RA-21-0320
December 20, 2021

MCGUIRE NUCLEAR STATION, UNIT NOS. 1 AND 2
DOCKET NOS. 50-369, 50-370 / RENEWED LICENSE NOS. NPF-9 AND NPF-17

SUBJECT: License Amendment Request (LAR) to Revise the Applicability Term for Pressure and Temperature Limit Curves of Technical Specification 3.4.3, "RCS Pressure and Temperature (P/T) Limits"

Figure 3.4.3-3 McGuire Unit 2 Reactor Coolant System Heatup Limitations (Heatup Rate of 60°F/hr) Applicable for the First 34 EFPY (Without Margins for Instrumentation Errors) Using 1996 App.G Methodology & ASME Code Case N-641

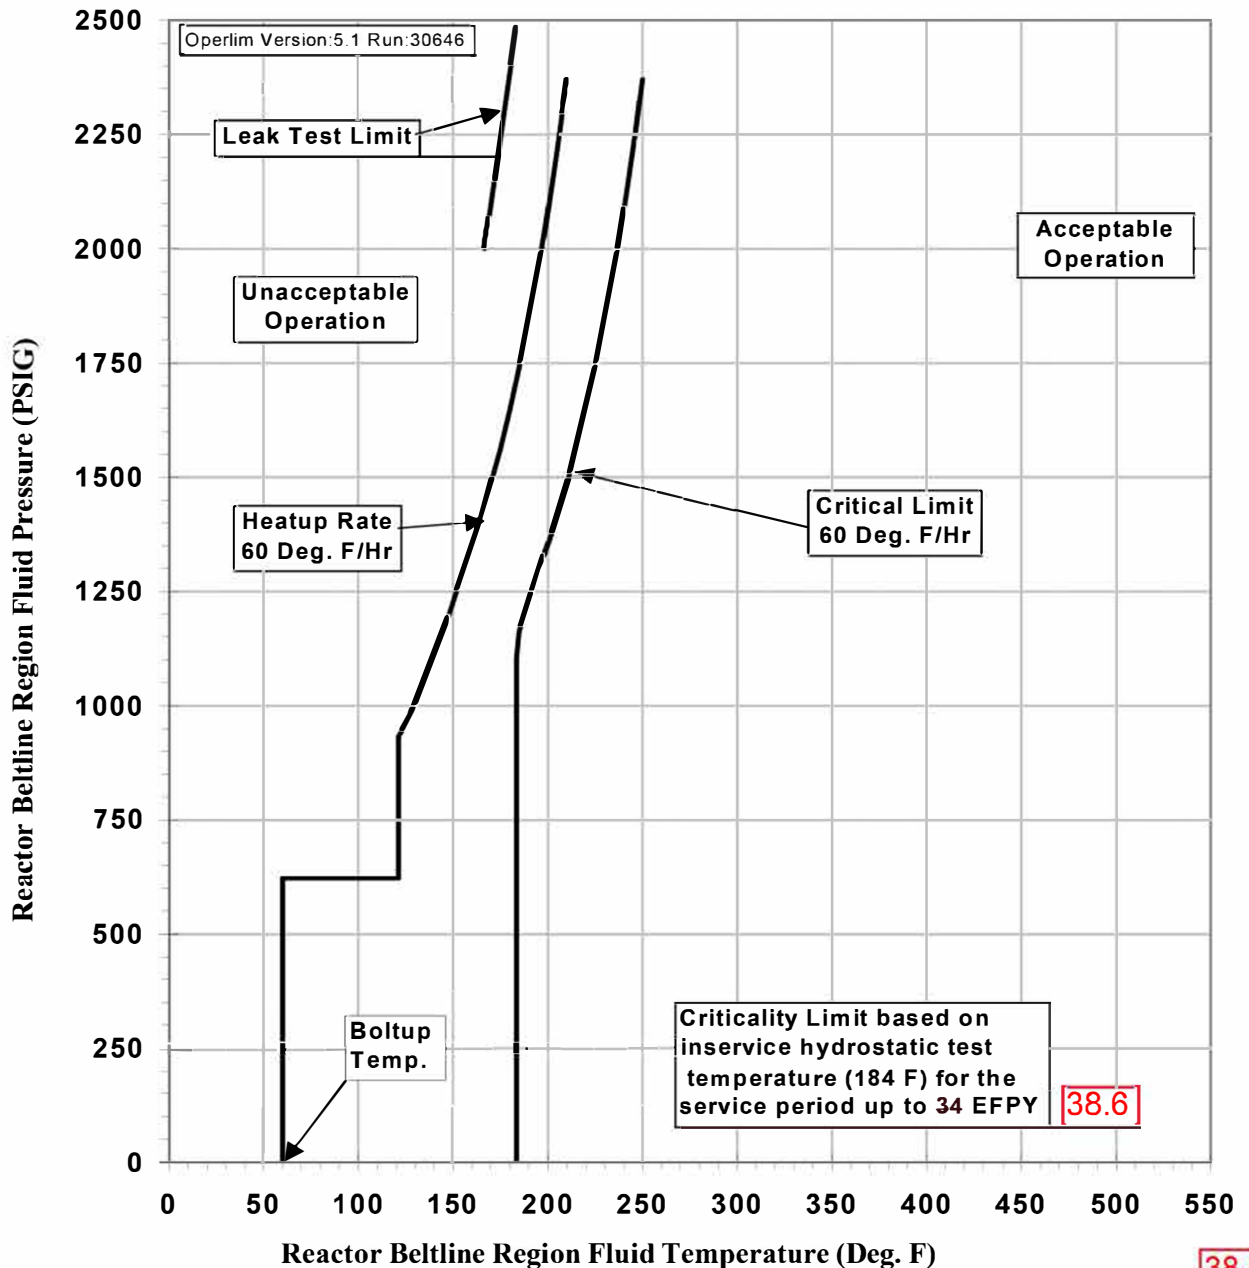
In addition, the statement in each Figure, "Limiting ART values at 34 EFPY," as shown above in Section 2.2 revises the applicability term statement for the limiting ART values (i.e., Limiting ART values at 34 EFPY) to reflect 54 EFPY for Unit 1 and 38.6 EFPY for Unit 2.

Finally, the proposed change revises the "Criticality Limit" note in the Figures as described in Section 2.2 to reflect an applicability period of 54 EFPY for Unit 1 and 38.6 EFPY for Unit 2.

38.6

Figure 3.4.3-4 McGuire Unit 2 Reactor Coolant System Heatup Limitations (Heatup Rates of 80 & 100°F/hr) Applicable for the First 34 EFPY (Without Margins for Instrumentation Errors) Using 1996 App.G Methodology & ASME Code Case N-641

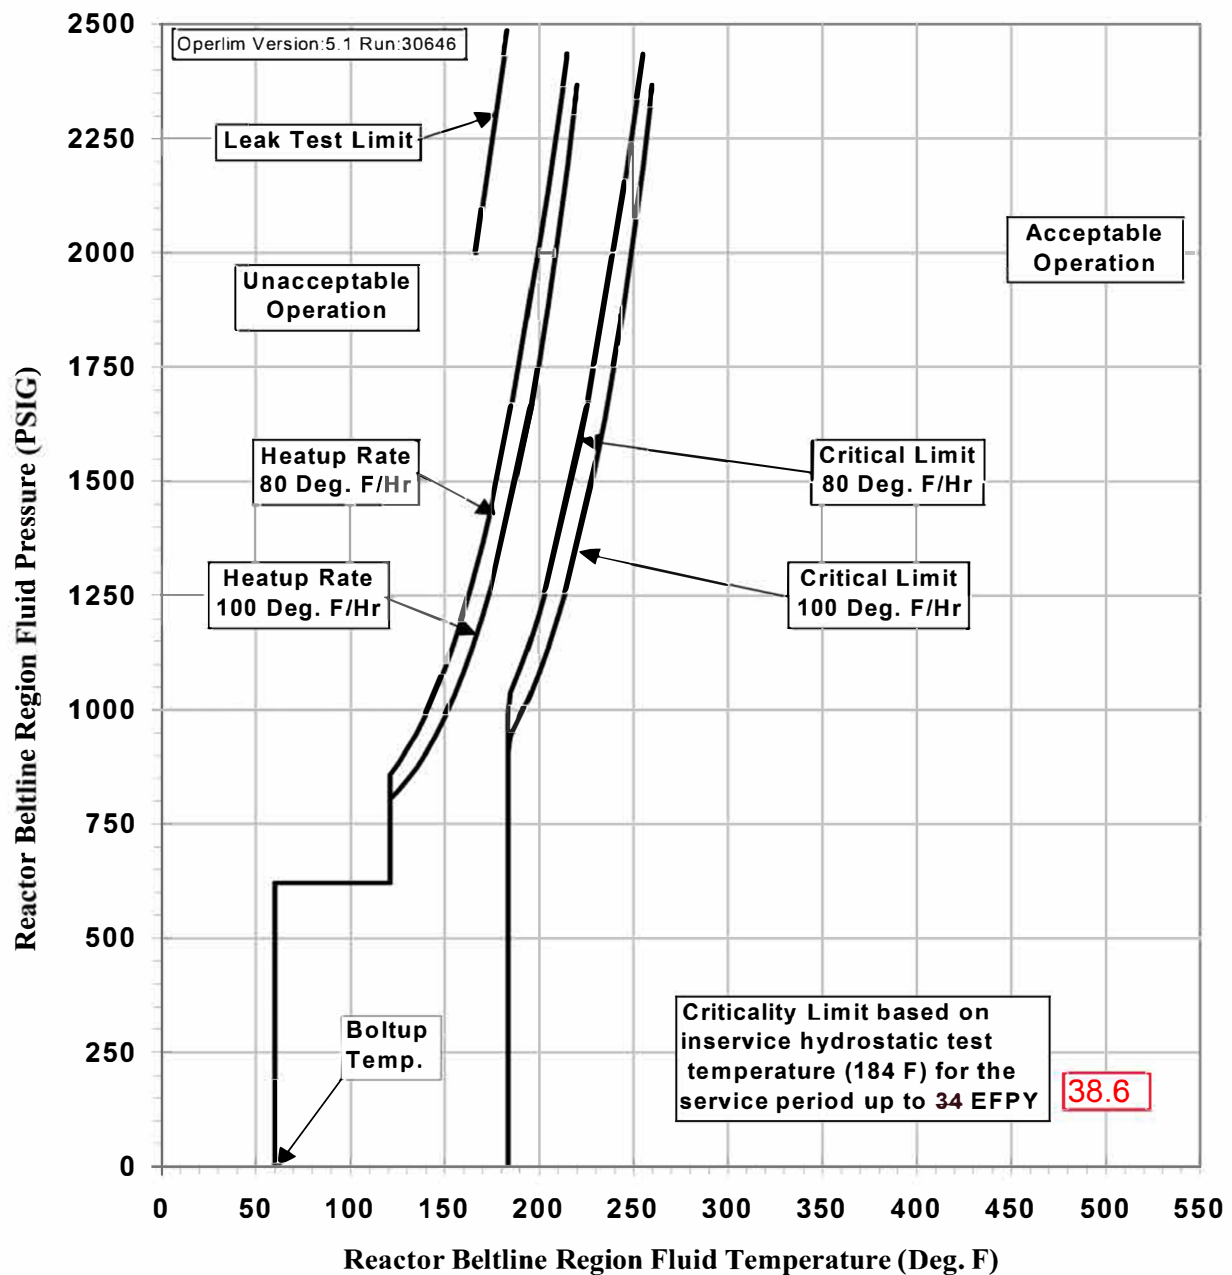
38.6

Figure 3.4.3-5 McGuire Unit 1 Reactor Coolant System Cooldown Limitations (Cooldown Rates up to 100°F/hr) Applicable for the First 34 EFPY (Without Margins for Instrumentation Errors) Using 1996 App.G Methodology & ASME Code Case N-641

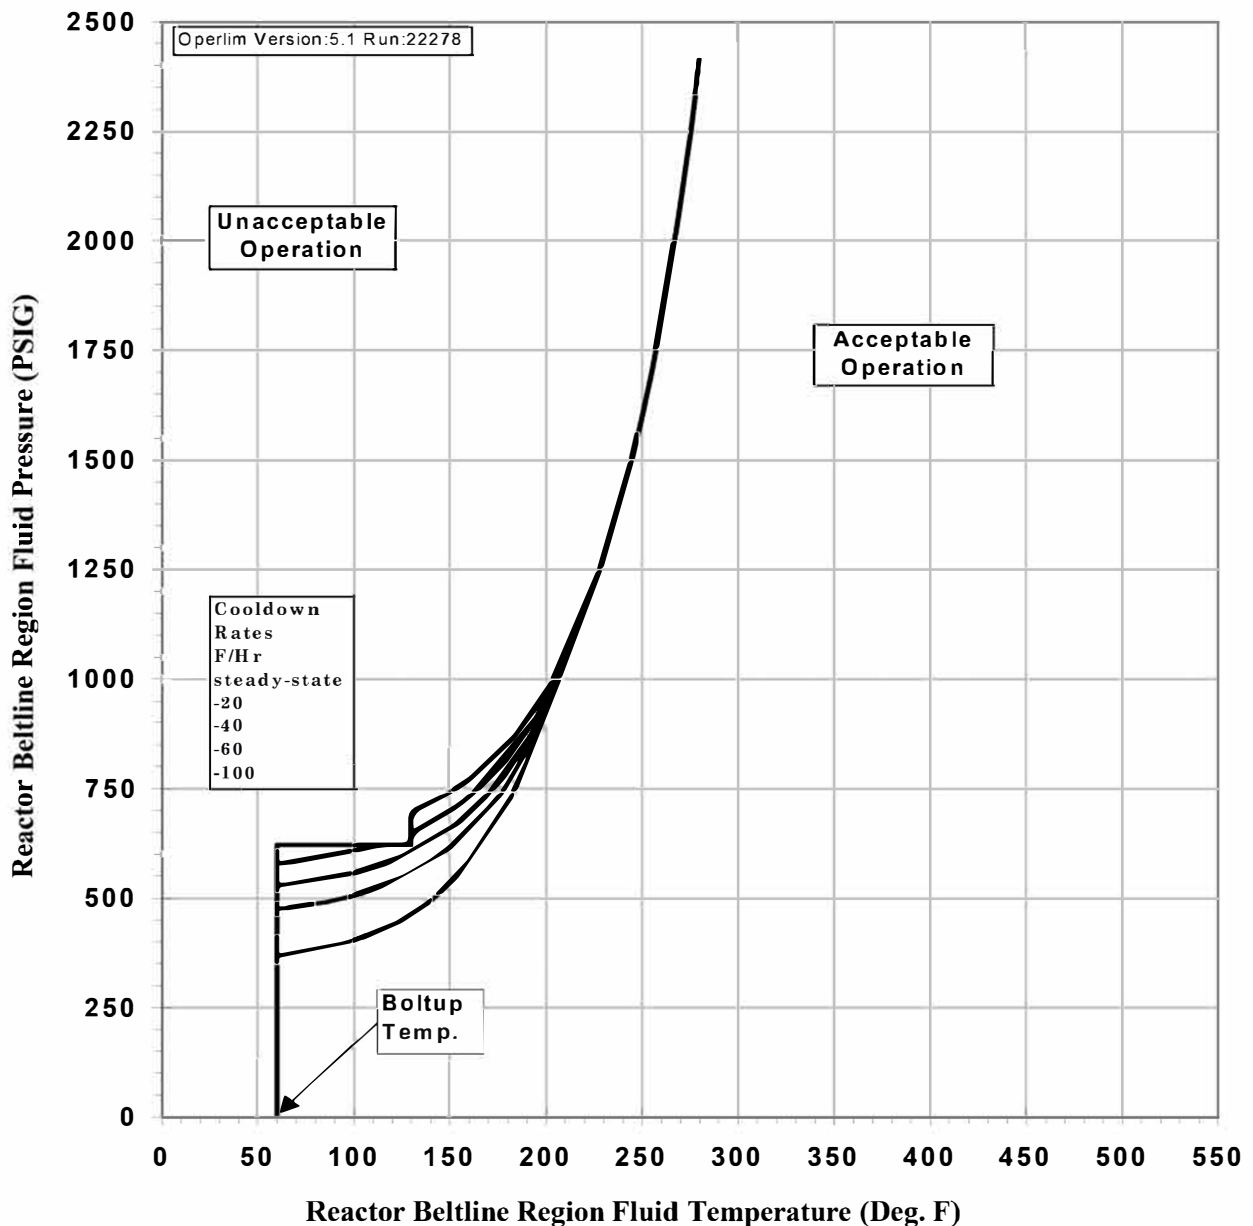
54

Figure 3.4.3-6 McGuire Unit 2 Reactor Coolant System Cooldown Limitations (Cooldown Rates up to 100°F/hr) Applicable for the First 34 EFPY (Without Margins for Instrumentation Errors) Using 1996 App.G Methodology & ASME Code Case N-641

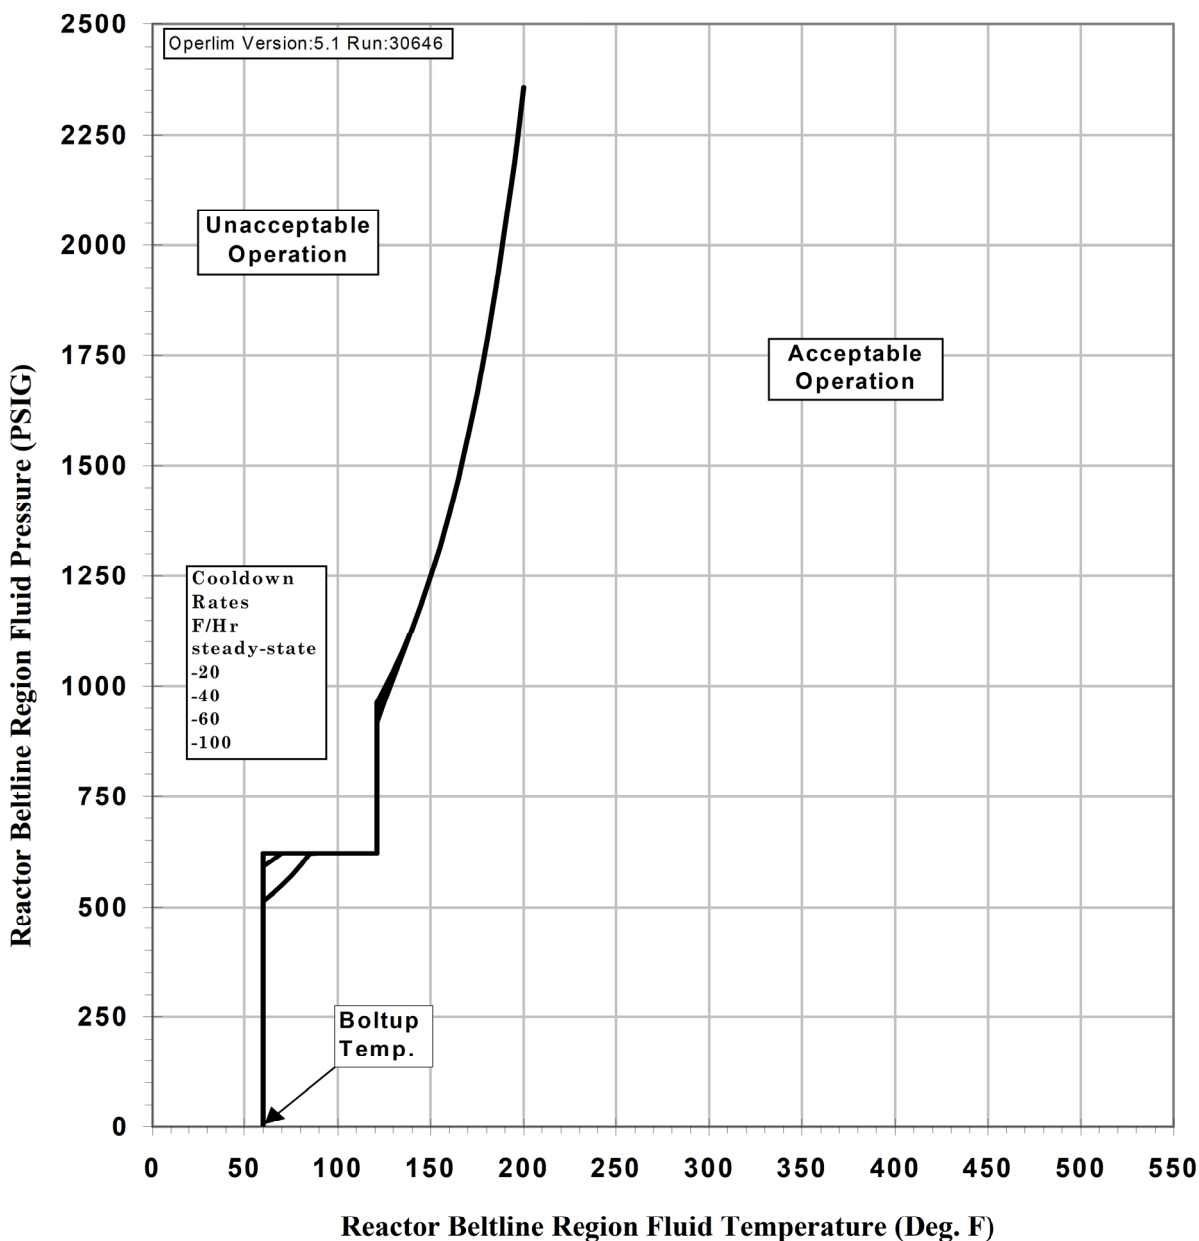
38.6

Figure 3.4.3-2 McGuire Unit 1 Reactor Coolant System Heatup Limitations (Heatup Rates of 80 & 100°F/hr) Applicable for the First 54 EFPY (Without Margins for Instrumentation Errors) Using 1996 App.G Methodology & ASME Code Case N-641

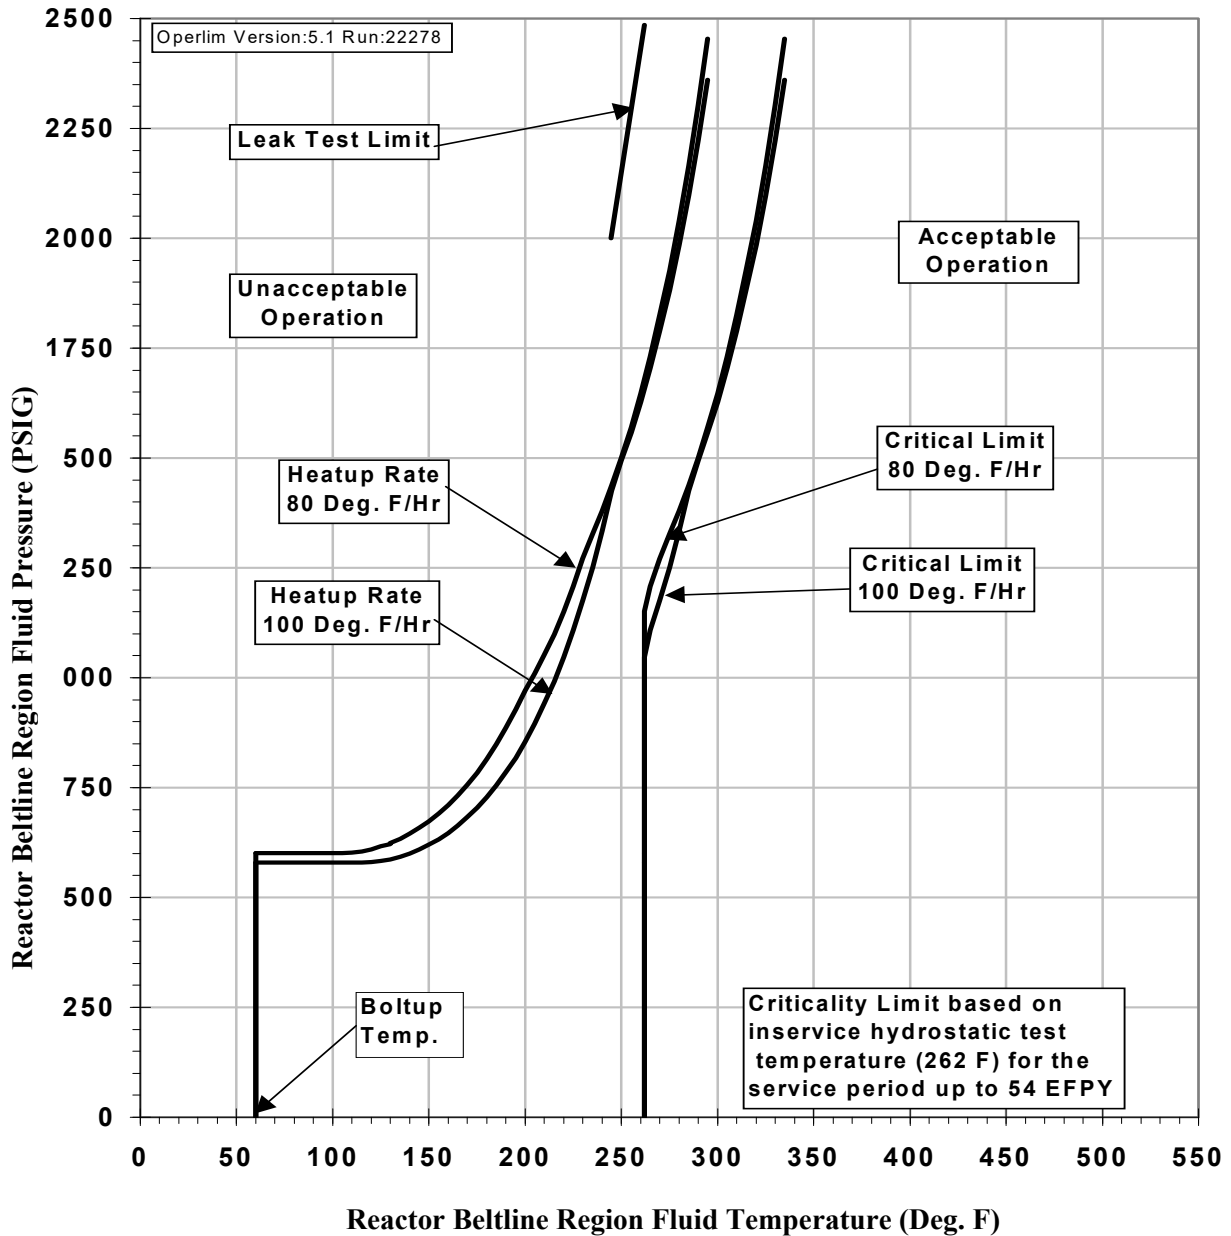
38.6
